**City of Portsmouth, NH**  
**Bid #29-13 Mechanic Street Seawall at Pickering**

**ADDENDUM No. 1**

**Issued February 25, 2013**

PREPARED BY: Vine ASSOCIATES A DIVISION OF GZA GeoEnvironmental, Inc. ENGINEERS AND SCIENTISTS www.gza.com  
PREPARED FOR: CITY OF PORTSMOUTH, NH

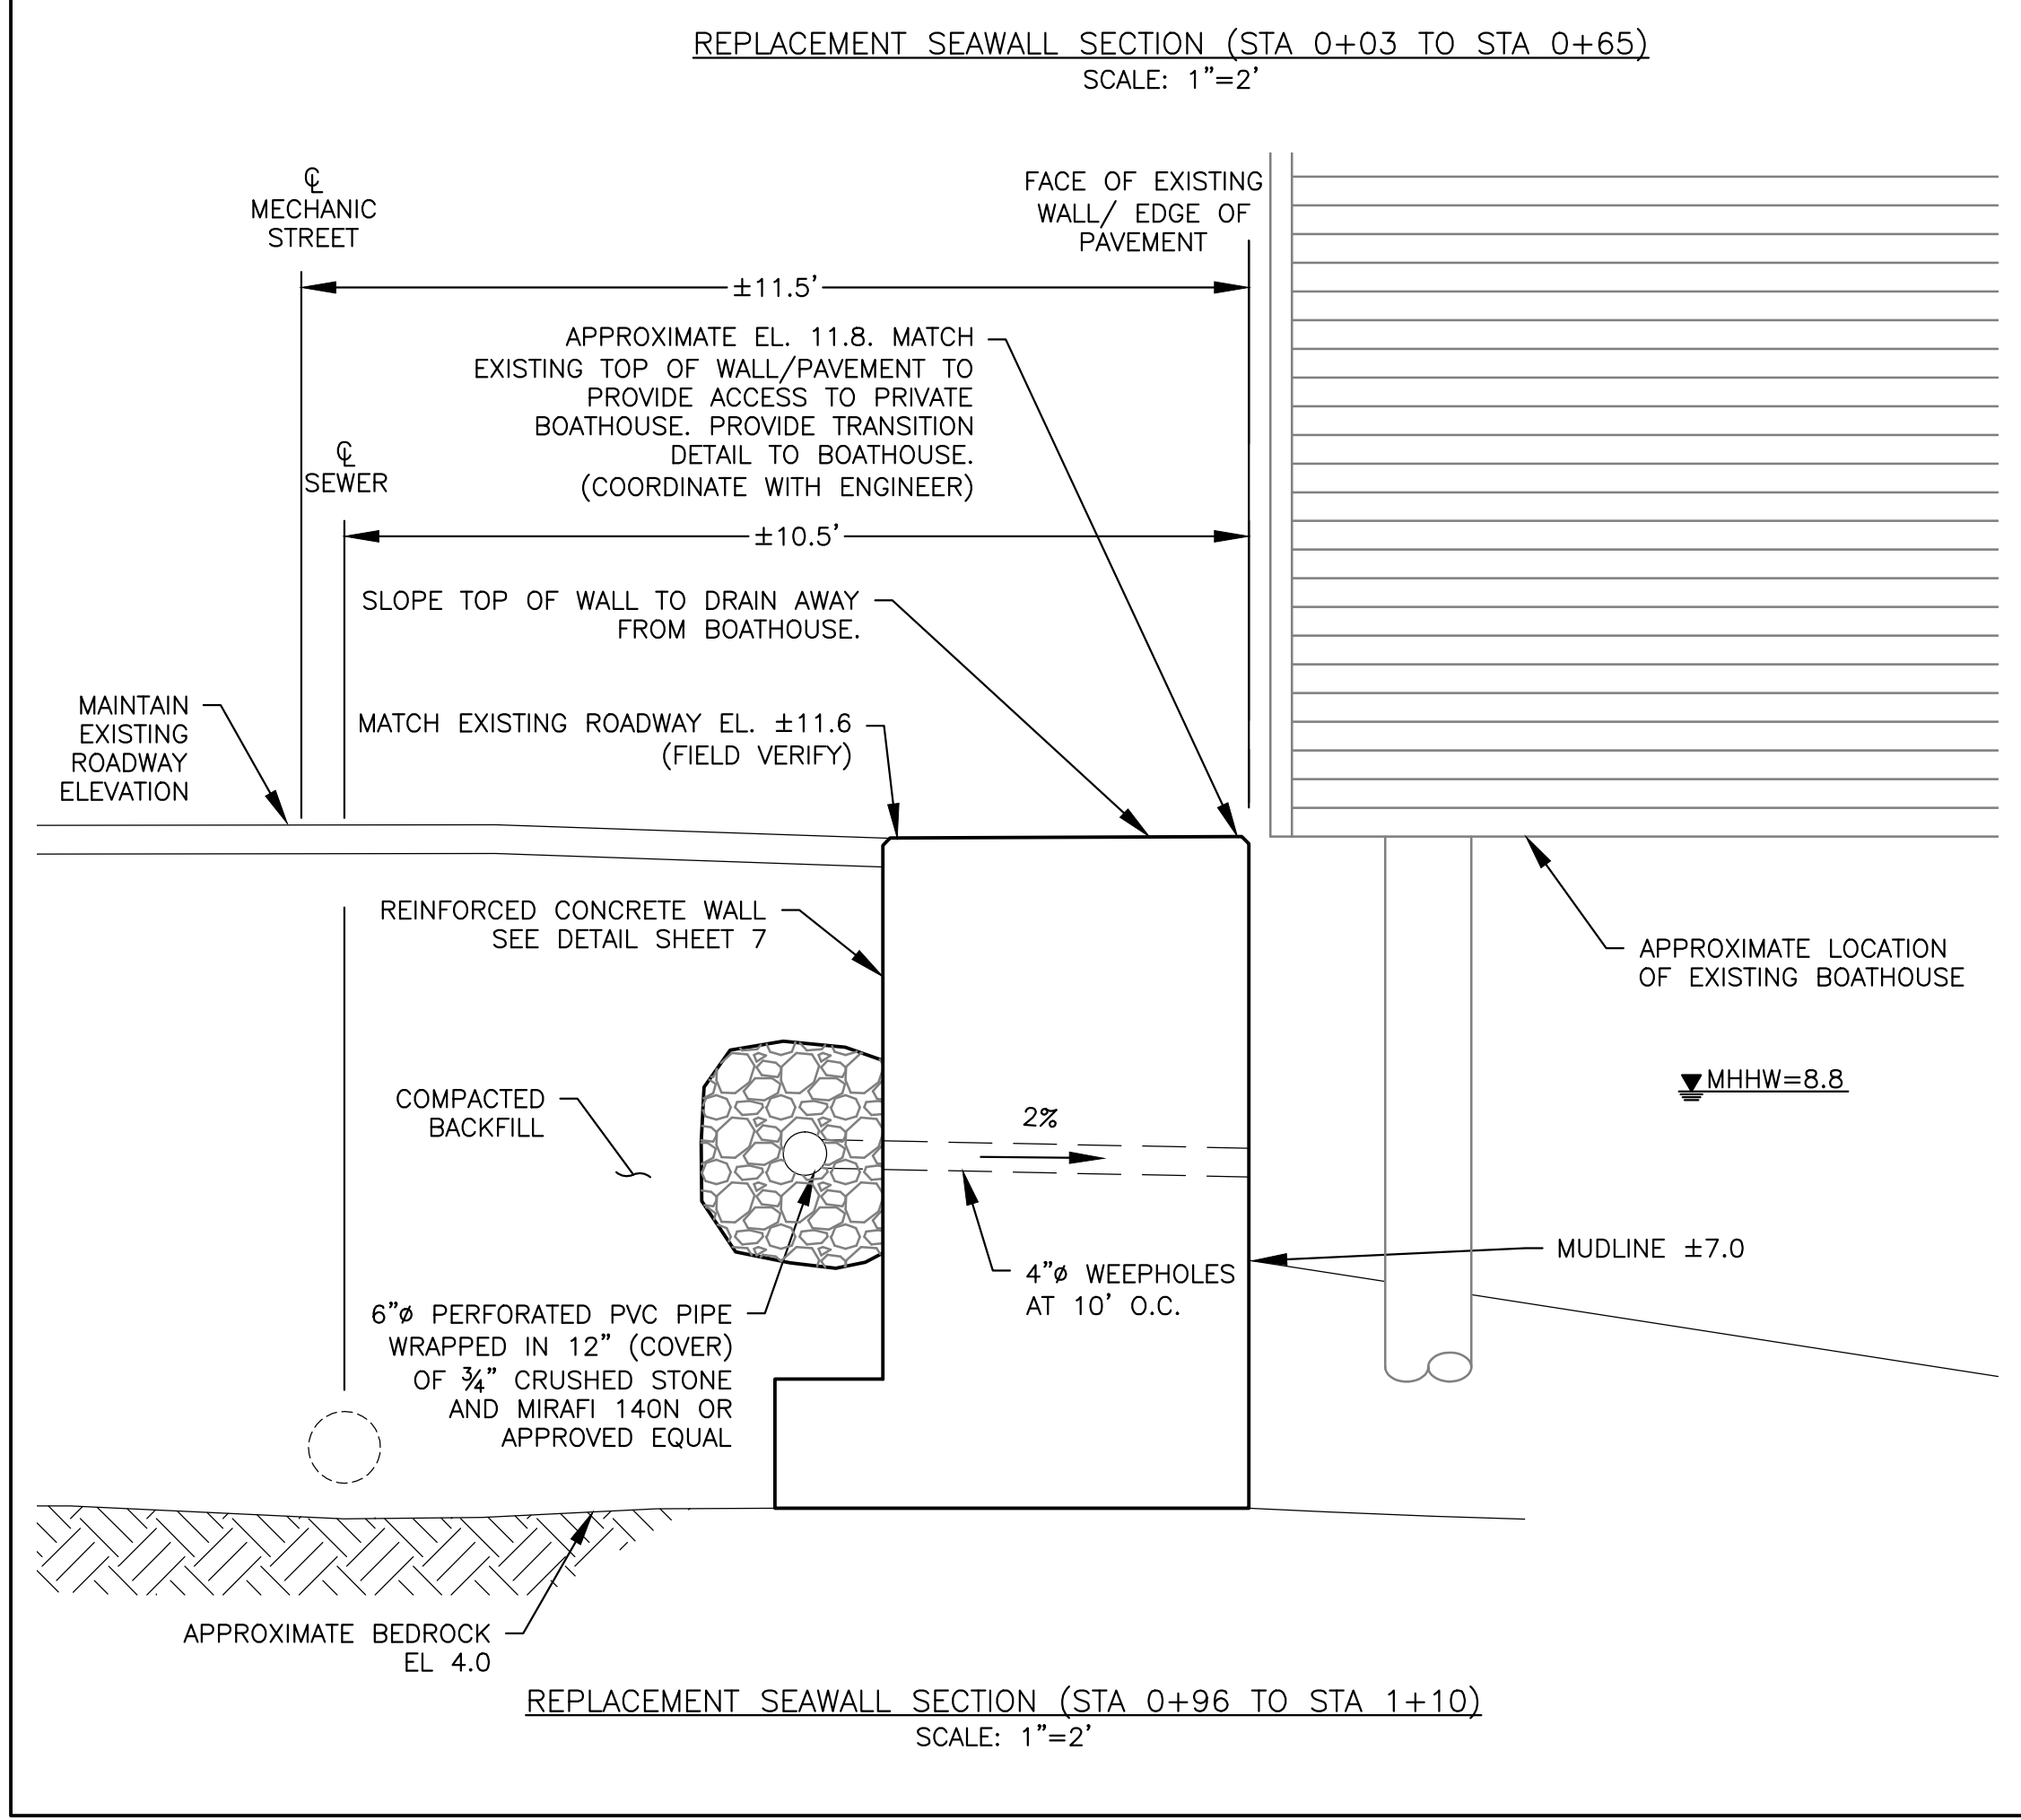
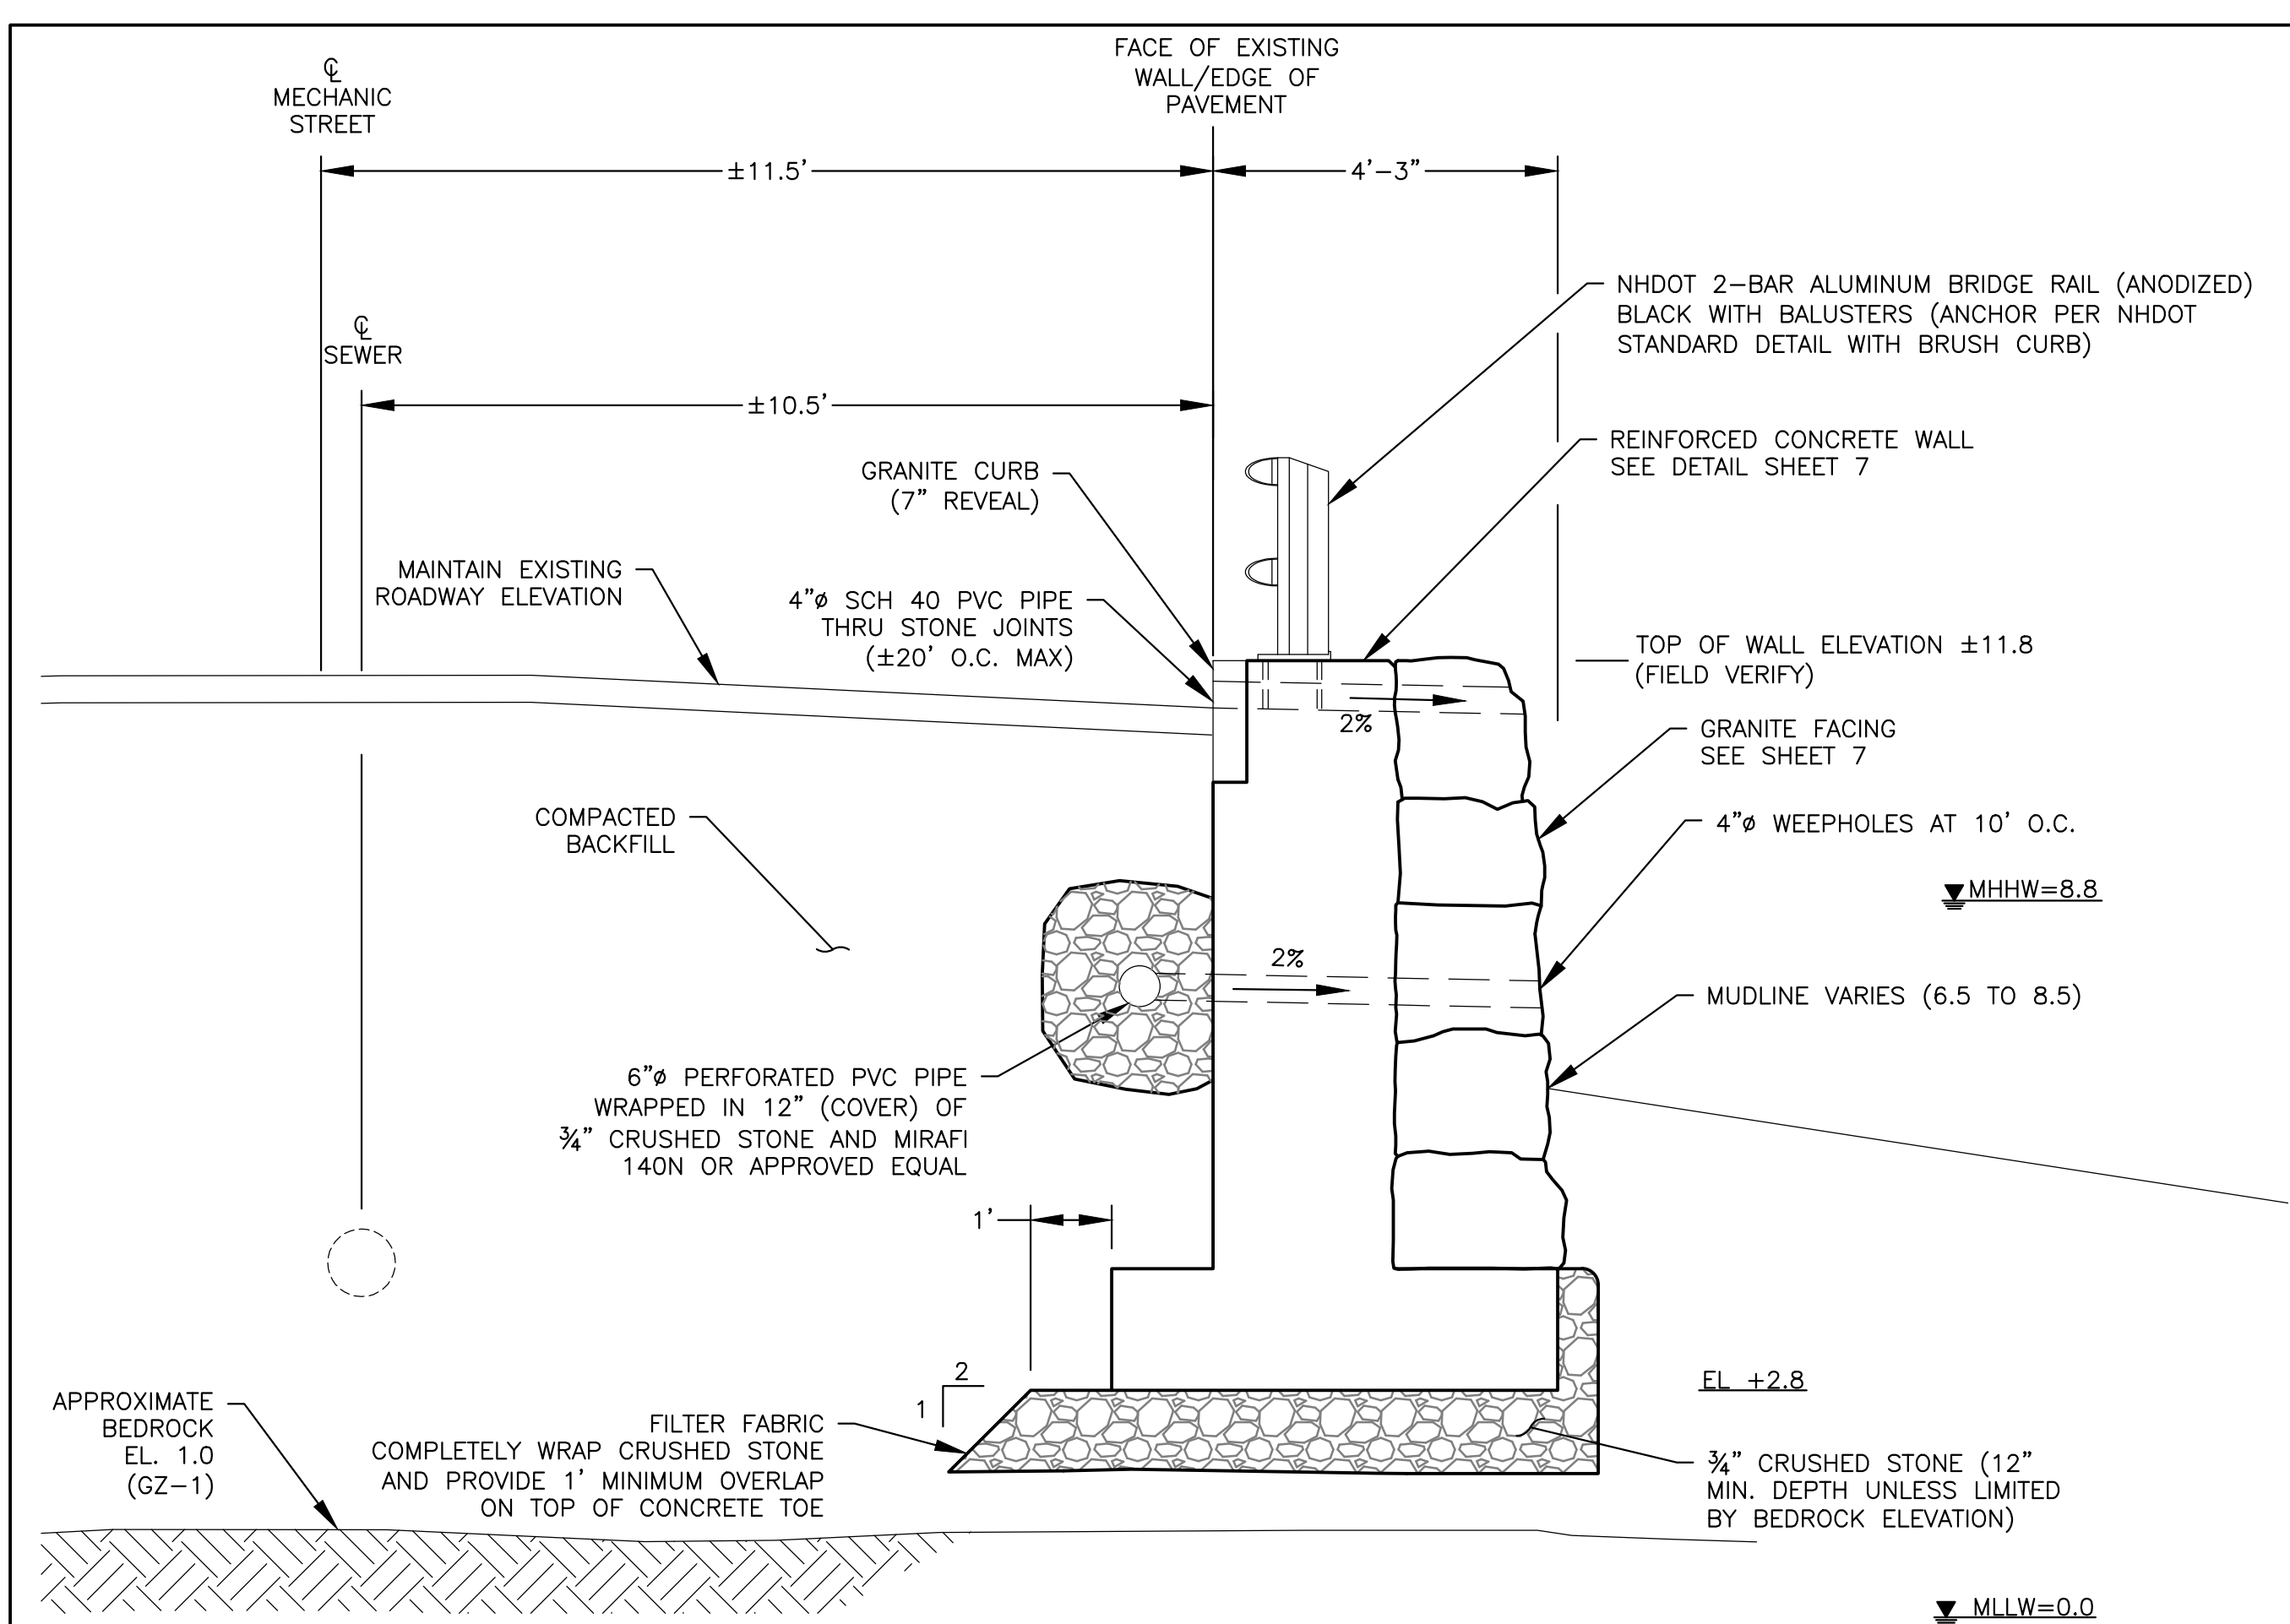
2. Drawing 6 shows a detail "Replacement Seawall Reinforcing – 0+65 to 0+88." Should that be 0+88 to 1+10?

Response: Drawing 6 has been revised to reflect corrected stationing. The section referenced in the bidder question is from STA 0+65 to STA 0+96, which is approximately 1 foot beyond the side of the boathouse.
